**F/YR24/0509/RM**

**Land South Of 73-81, Upwell Road, March, Cambridgeshire**

**Reserved Matters application relating to detailed matters appearance, landscaping, layout and scale pursuant to outline permission APP/D0515/W/23/3327578, relating to application F/YR22/0062/O to erect 110 x dwellings (3 x 1-bed flats, 3 x 2-bed flats, 32 x 2-storey 2-bed, 4 x 3-storey 3-bed, 55 x 2-storey 3-bed and 13 x 2-storey 4-bed)**

**Officer recommendation: Grant subject to conditions**

TITLE: PLANNING LAYOUT

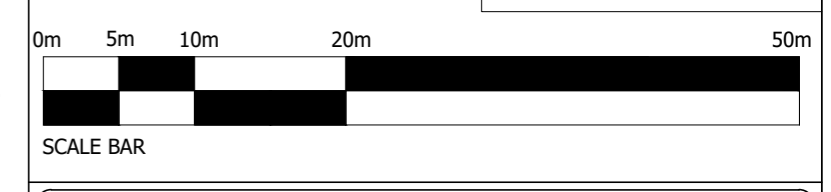
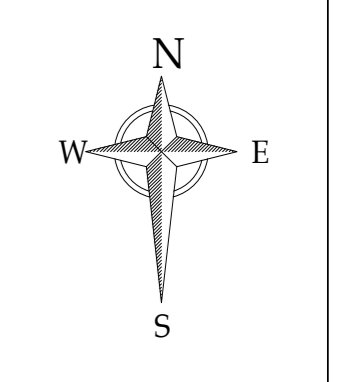
*The revised layout as shown on the drawing 1353-004 E has addressed my previous comments. Provided that it is constructed in line with Cambridgeshire County Council's Housing Estate Road Construction Specification, the internal roads are in principle suitable for adoption.*

Rev E: Build outs added to shared surface, ped vs plays added.	18.9.24
Rev D: Updated in line with Highway comments.	17.9.24
Rev C: Eastern drainage easement updated.	12.8.24
Rev B: Southern PROW widened to 3m.	8.8.24
Rev A: Attenuation area amended.	5.8.24
